Subject: Cdn Zinc TRS

July 23, 2001

Enclosed, for the consideration of the Mackenzie Valley Environmental Impact Review Board, are DIAND's information requests for the Canadian Zinc Corporation's environmental assessments for the Phase II Drilling Program and the Decline and Metallurgical Test Plant. If you require additional clarification on any of these requests please contact Ranjit Soniassy at 669-2591.

**Environmental Assessment - Technical Review Information Request #1****Canadian Zinc Corporation Prairie Creek Project****Decline Development, Exploration Drilling, and Metallurgical Pilot Plant Program**

Figure 1. Total groundwater volume is the integral of flow rate times the duration of flow.

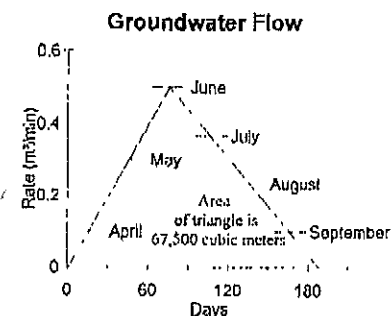
**Preamble:** The groundwater flows given for the 870m level adit suggest that throughout a summer about 67,500 m<sup>3</sup> of groundwater can issue from this adit 20m above the 850m elevation of the mine site, which suggests that the adit intersected a seasonally perched aquifer. The proposed decline from the 905m level will descend to near the 825m level approximately 1460 m upstream of the mouth of Harrison Creek, where a greater hydraulic head may be encountered which is likely to produce greater flows than at the 870m level if the decline intersects a similar aquifer. The report also states that the probability of sump failure in the decline is "low" and the consequences of failure would be "small" volumes of "water and suspended solids", to "max. 50 gals.", which are "unlikely to migrate much beyond drill pad". A flow rate of 0.5 m<sup>3</sup>/min will yield 50 U.S. gals. in 2.5 minutes, and can potentially flood the end of a 15% decline (2.3m high by 3m wide) to the ceiling and 15m along its length in 1 hour.

Well and pump hose No.1 on the flood plain mine site are also a source of data for deriving hydraulic conductivity of the sands and gravels which underlie the tailings pond.

**Request:** A statement is required of intent to monitor and report the rate of groundwater flow encountered in the decline, and to commission pumps capable of handling the flow, with sufficient backup pumps in the event of pump failure(s). Also requested is an analysis of the hydraulic conductivity of the flood plain sands and gravels using draw-down and pumping-volume data from well and pump hose No. 1, and information on what treatment of the tailings impoundment will be undertaken to counteract this hydraulic conductivity.
